Reference: **Radioactive Materials License SUA-648; Docket No. 040-0299**
Subject: **Request for License Amendment to License Condition 35A – Appendix M**

Appendix M

Groundwater Monitoring Plan Gas Hills, Wyoming

March 2002
Revised October 2011

Fig-M-1(Oct2011).dwg

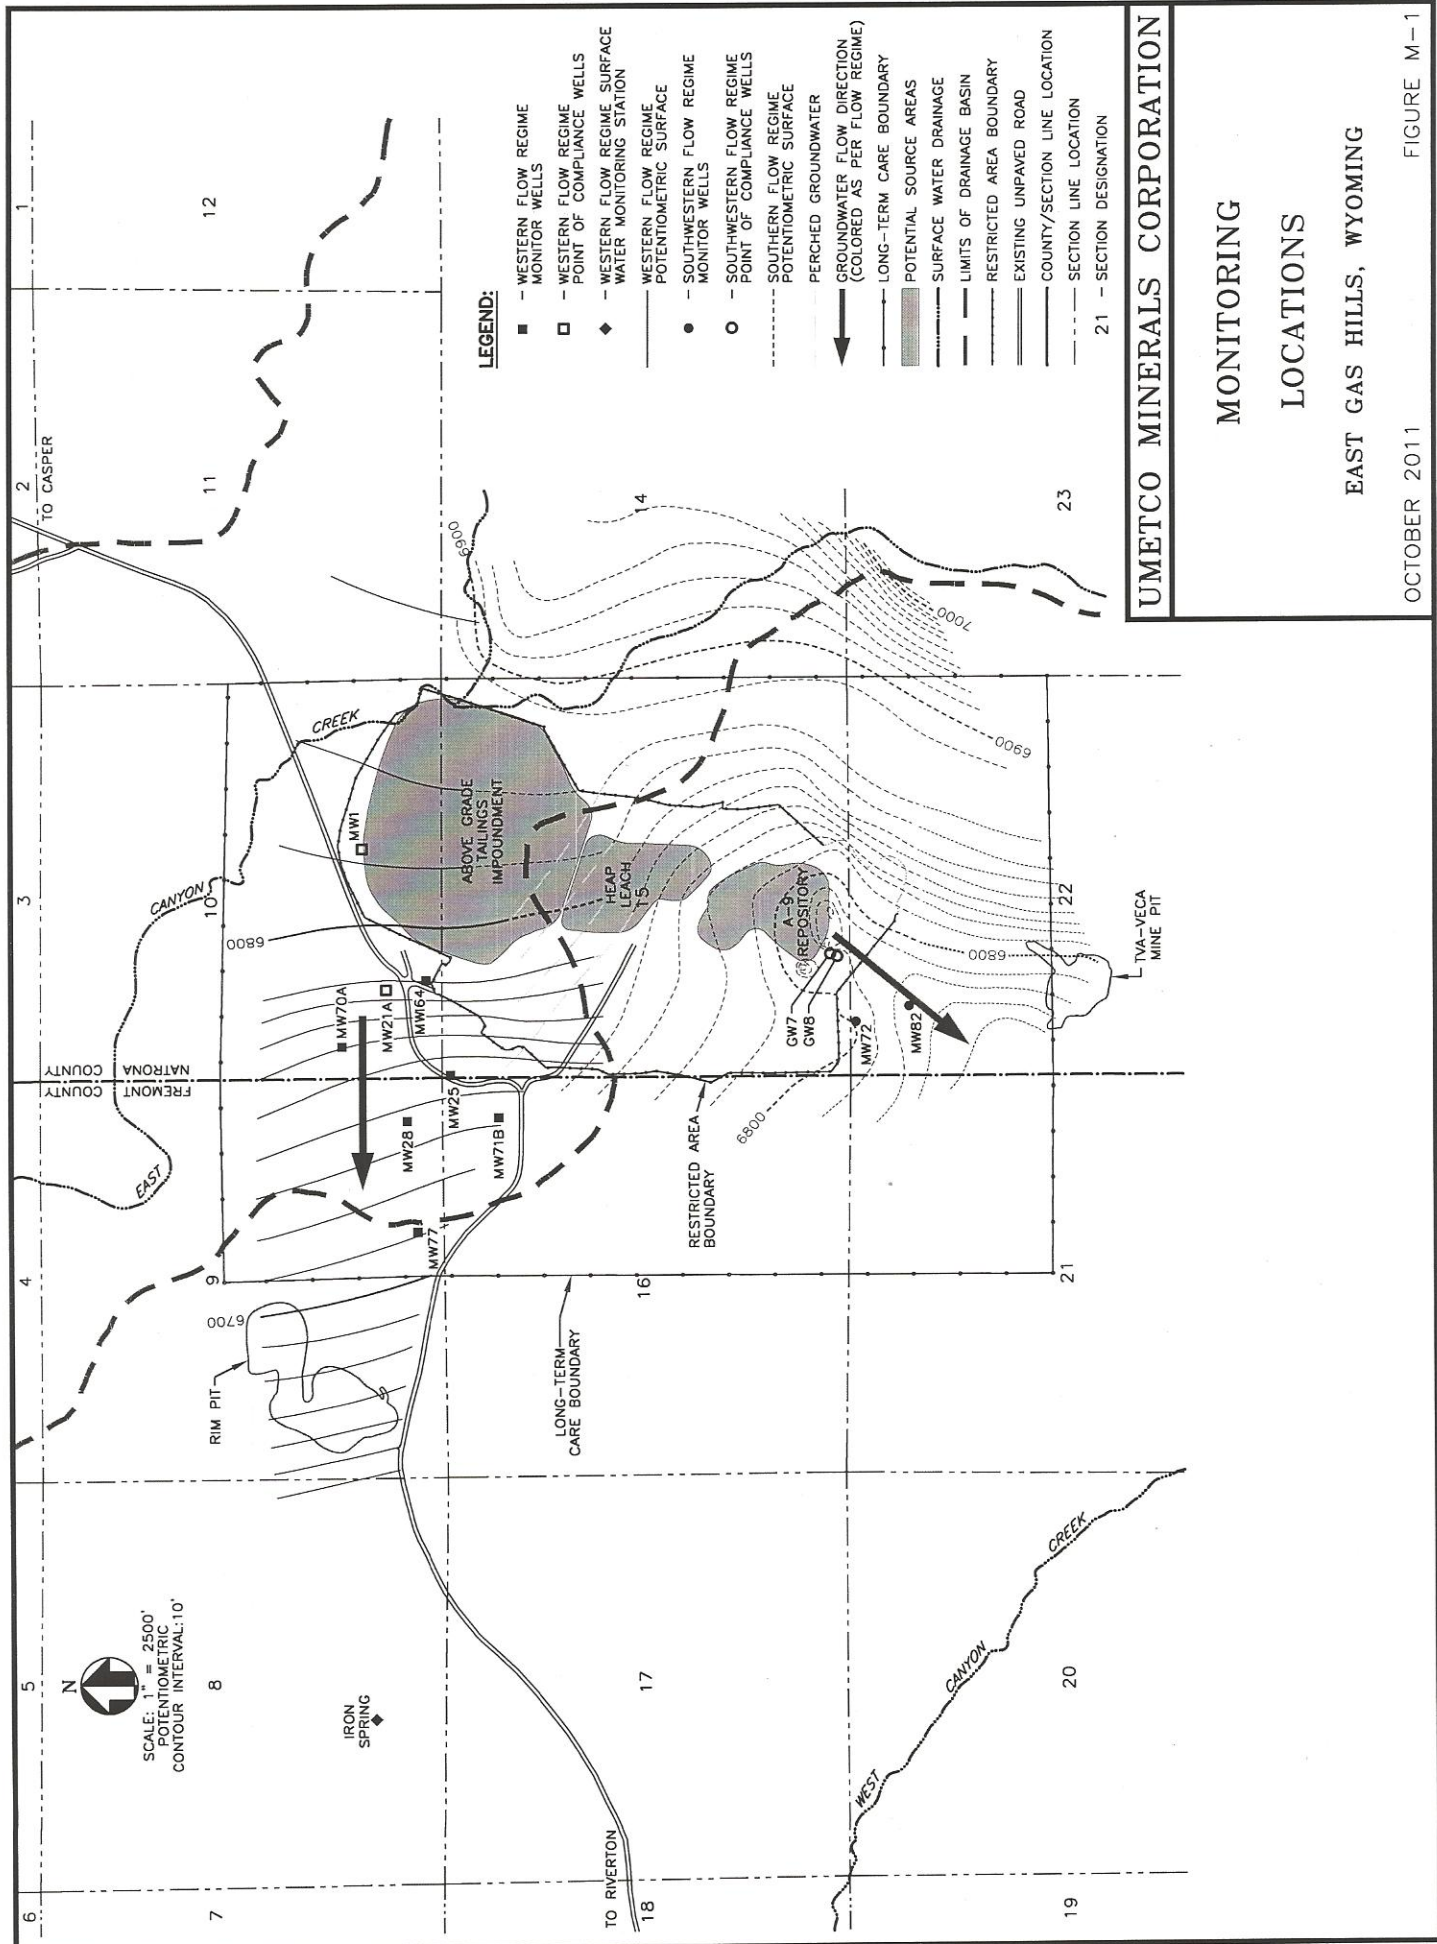
Per the telephone conversation with you today, Umetco Minerals Corporation (Umetco) has reviewed the submittal dated June 9, 2011, which requested modifications to Appendix M – Groundwater Monitoring Plan, for completeness. The attached October 2011 revision to Appendix M has been reviewed to ensure all references to semi-annual sampling have been deleted along with any reference to monitoring well PW4.
